ADDENDUM NO. 3

Williams Brice Stadium Plaza Site Upgrades – Construction

State Project No. H27-6104-MJ-B

R02 ROOF ASSEMBLY - R-02
3" = 1'-0"

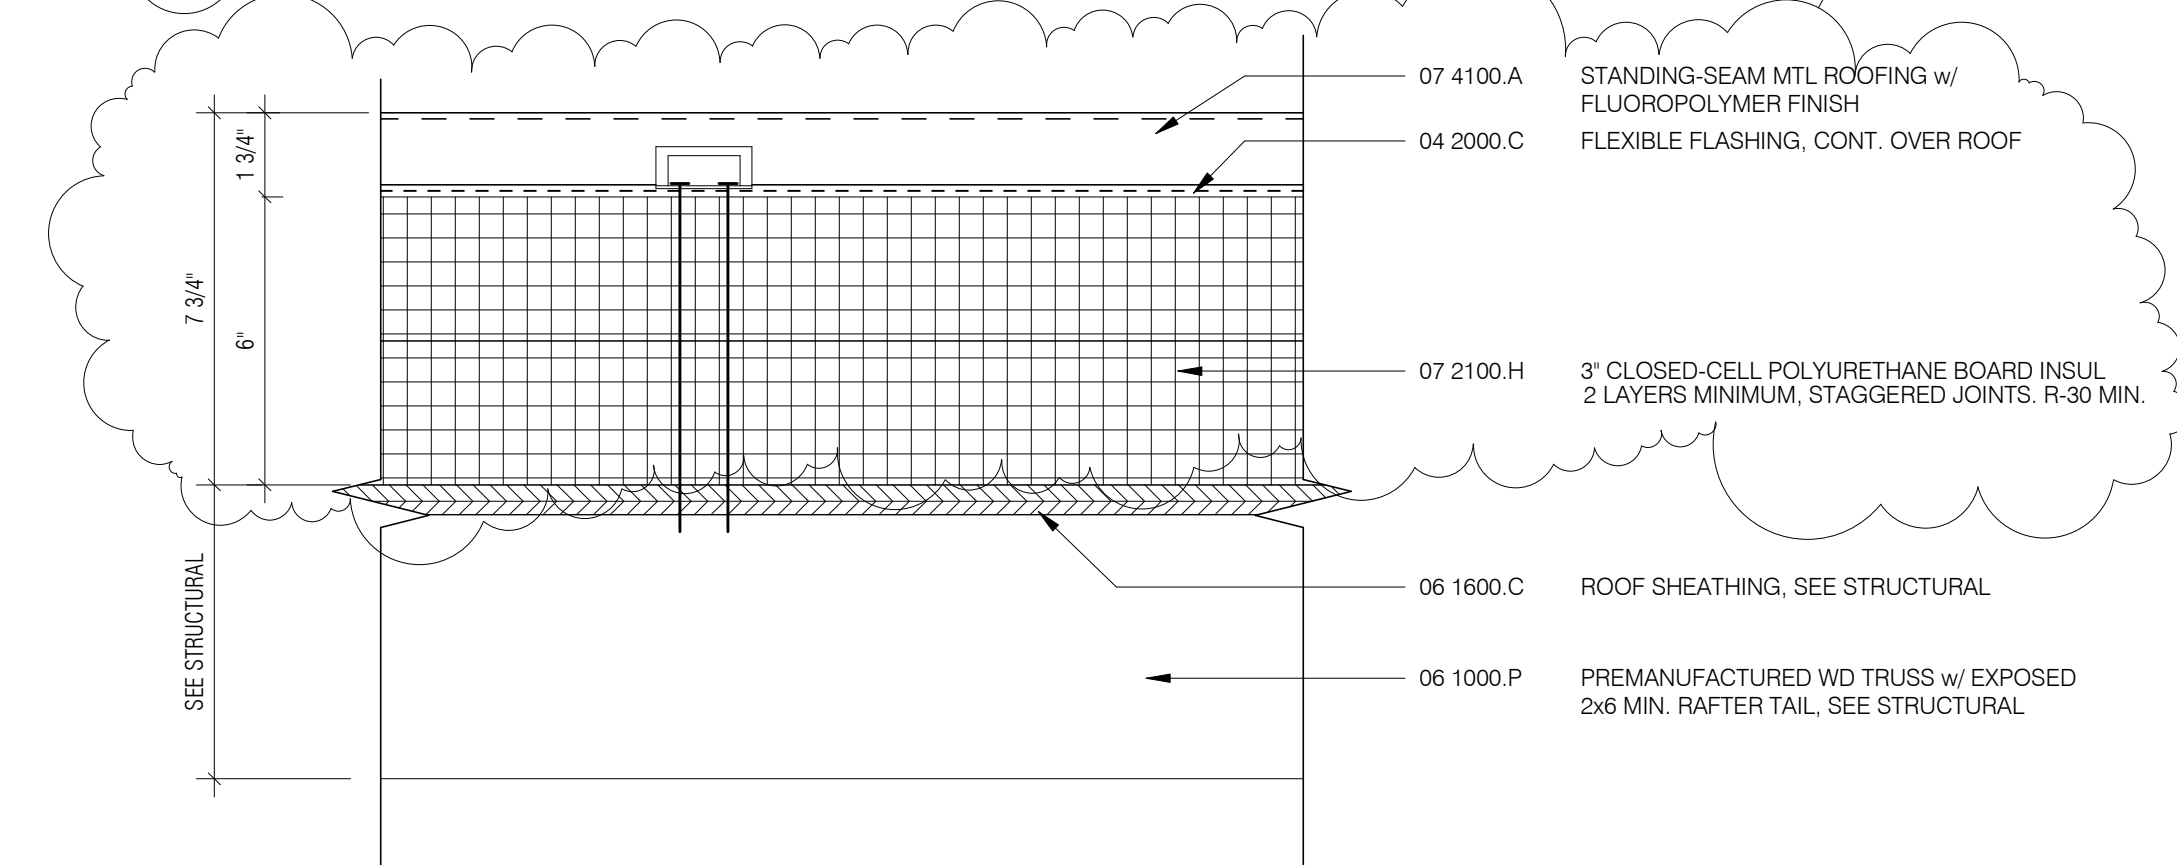
1. Drawing **“Assembly Types” A002**, at details R01 and R02, modify the insulation thickness per the attached revised drawings.

Comment: Minimum R value is to be R-30. Provide thickness as required at all conditions on the Gameday Building and Satellite Ticket Office. This addendum changes all of the roof details related to those buildings, whether specifically noted here or not. Note that this does not modify the Toilet Building and Electrical Building, which can remain at 3” total thickness.

1 ROOF PLAN
 A110 1/8" = 1'-0"

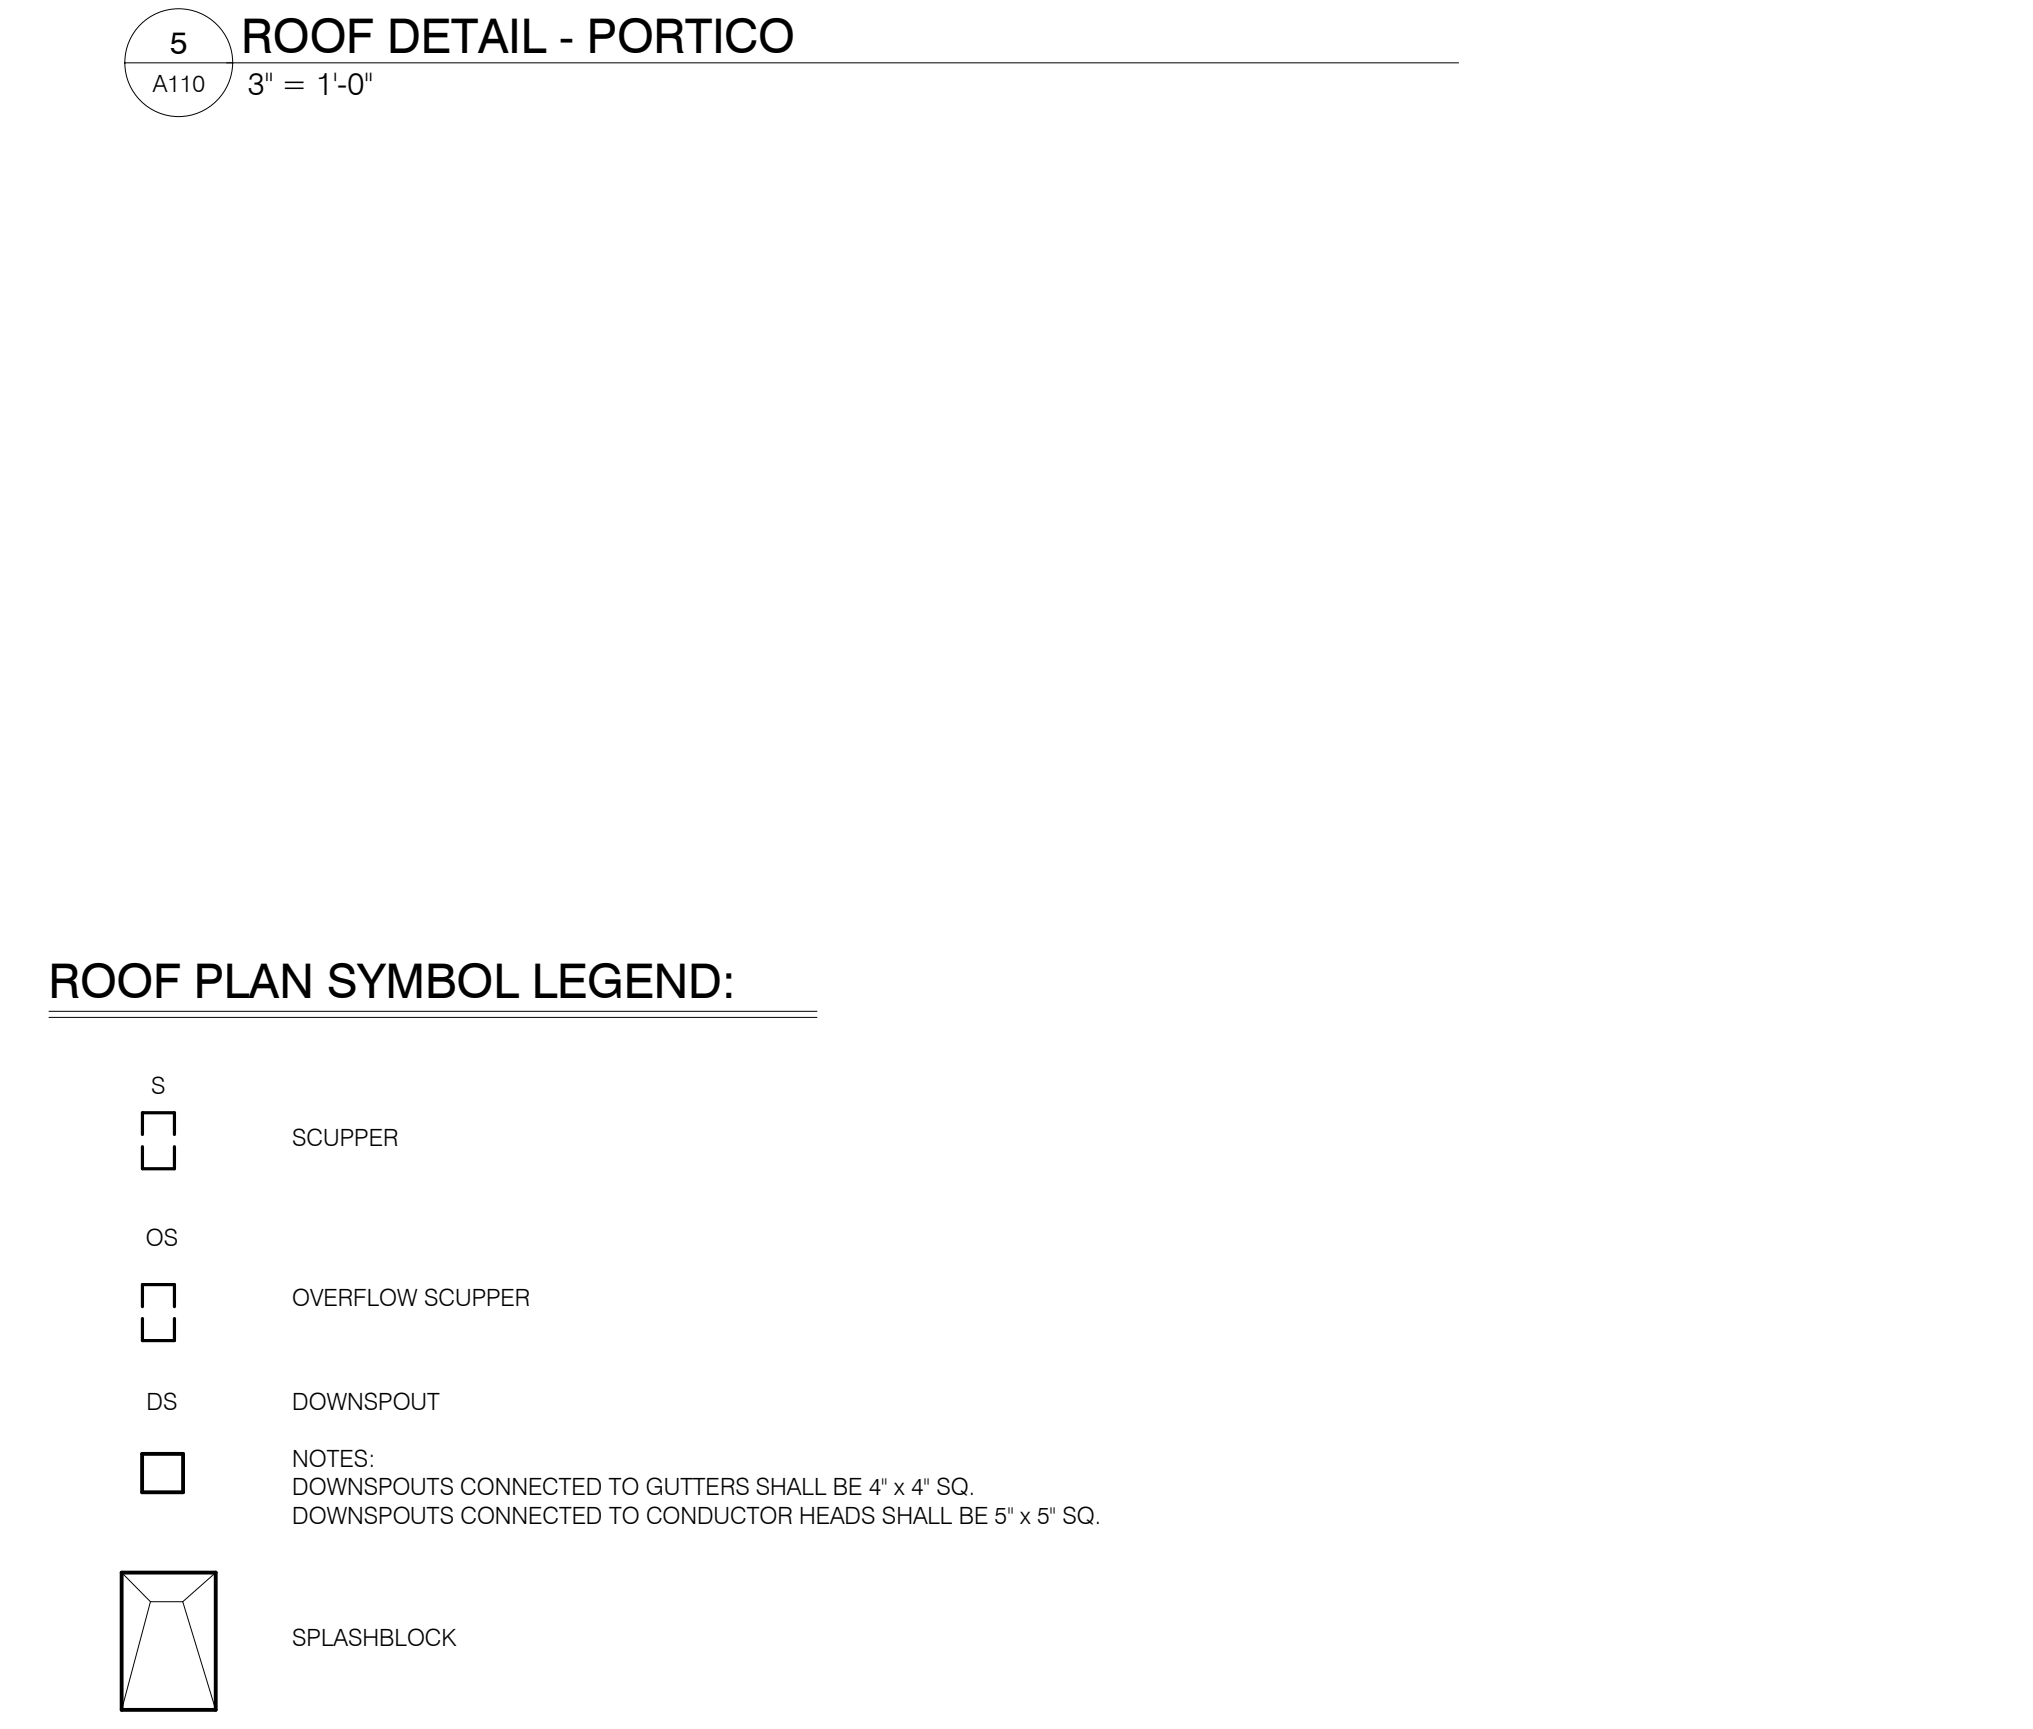
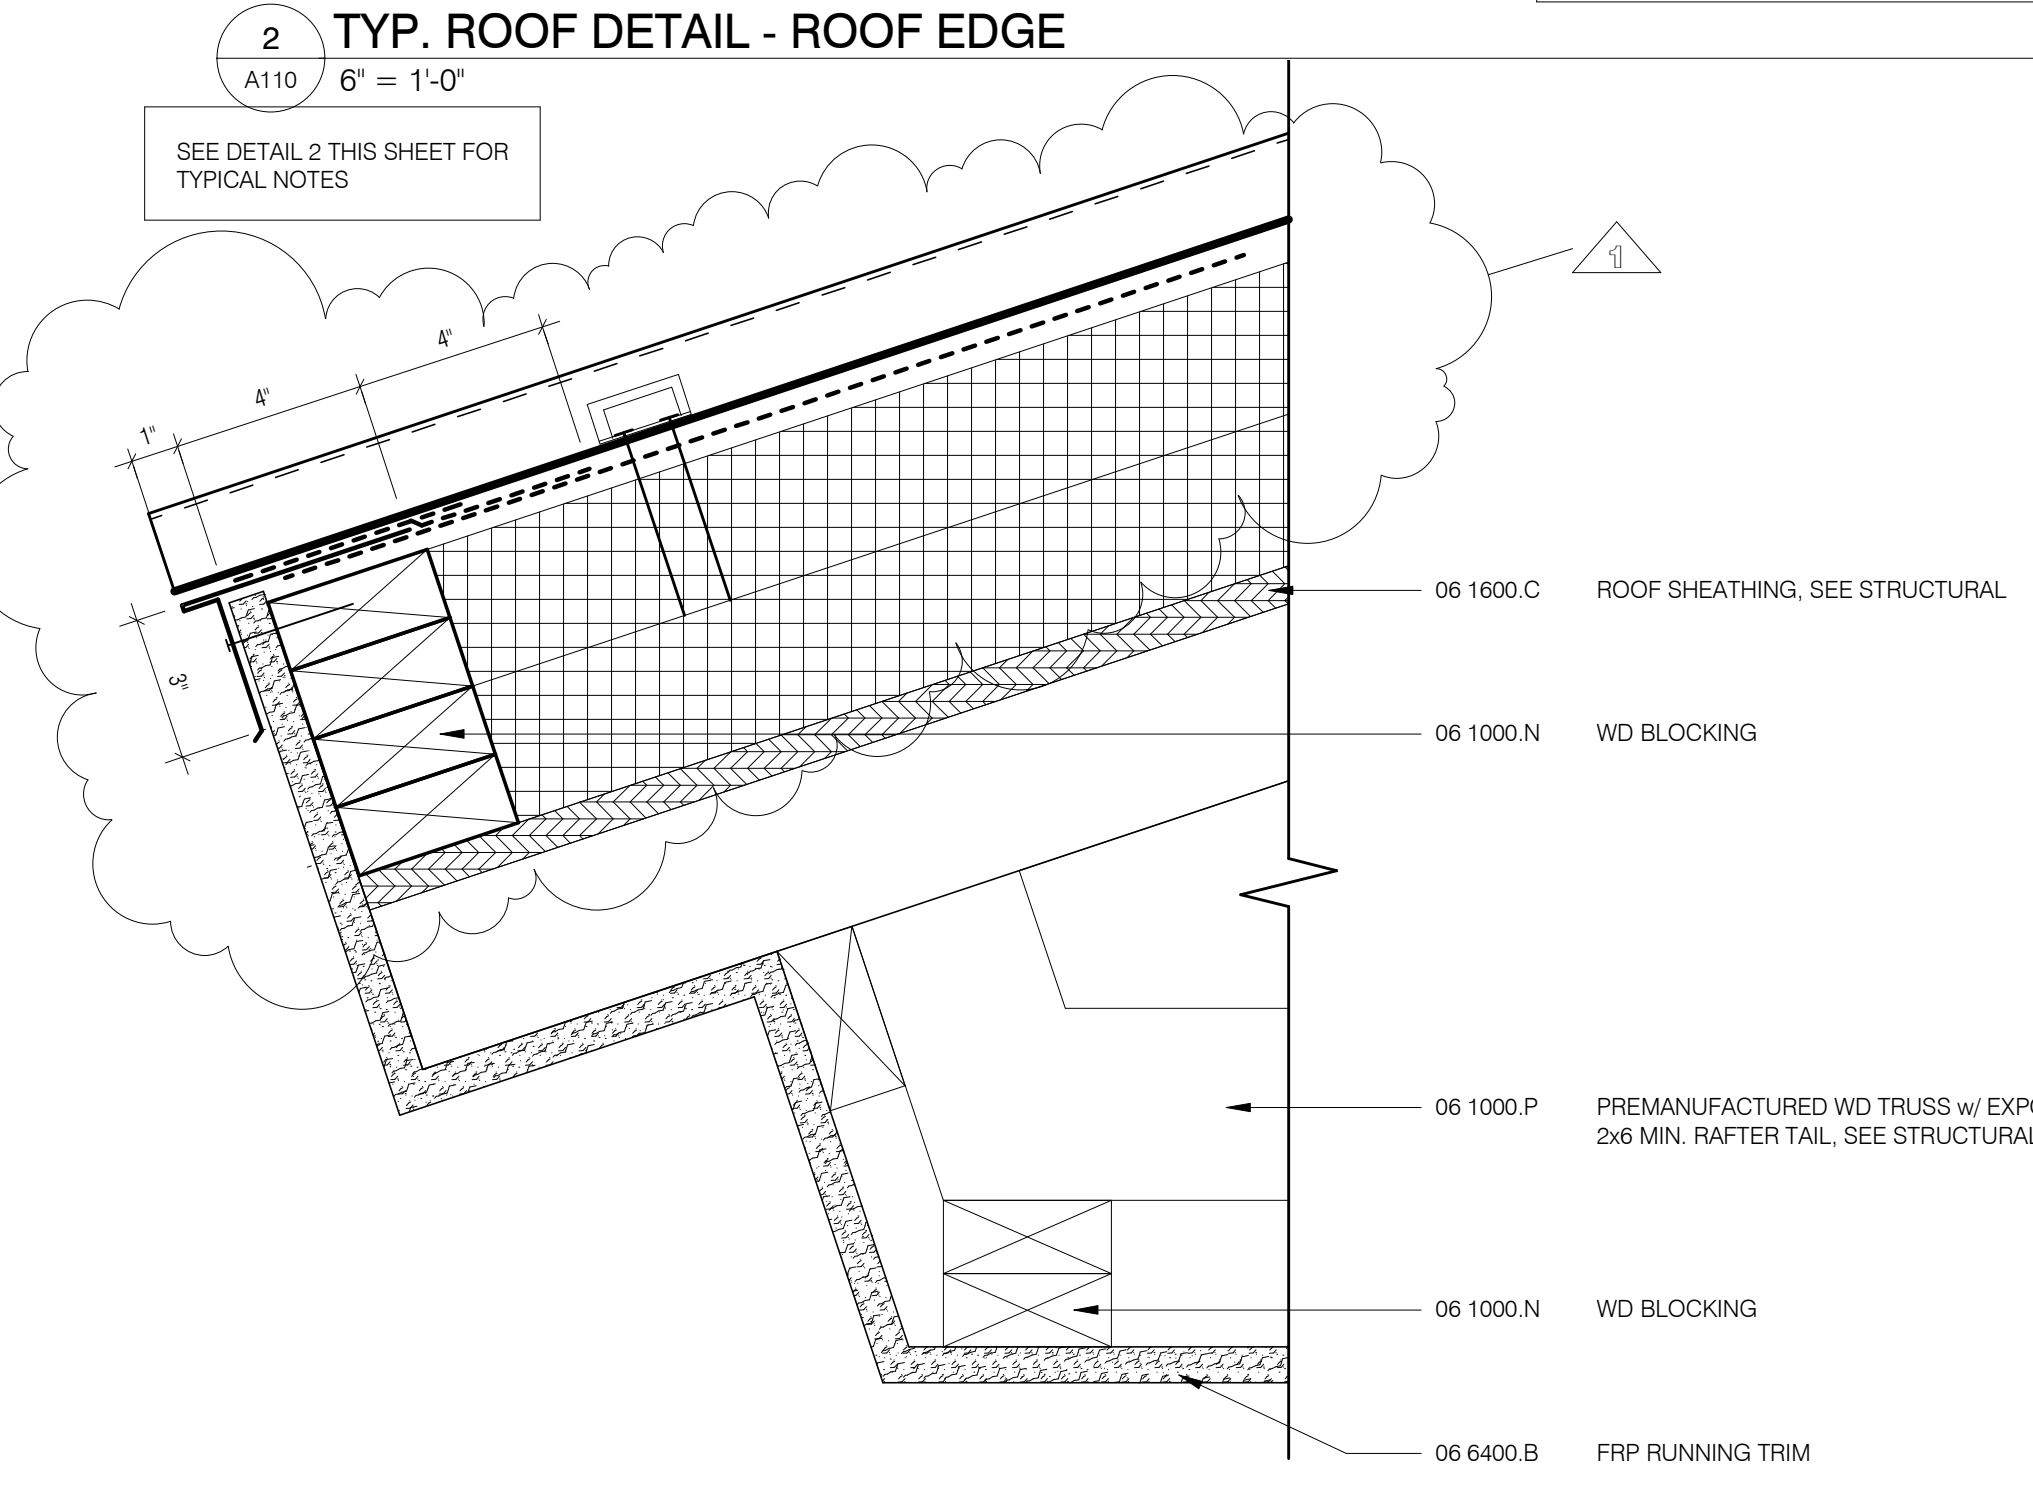
2. Drawing **“Roof Plan & Details” A110**, modify the typical roof details for the new R-value per the attached revised drawings.
3. Drawing **“FRP & Cast Stone Details” A161**, modify the FRP profiles per the attached revised drawings.
4. Contractors shall use plan sheet L200 and the legend contained therein for information pertaining to all concrete pavement locations and thicknesses. The Civil details and plans cover the asphalt pavements in the parking areas located just east of the Gameday building and on the south side of Key Road.
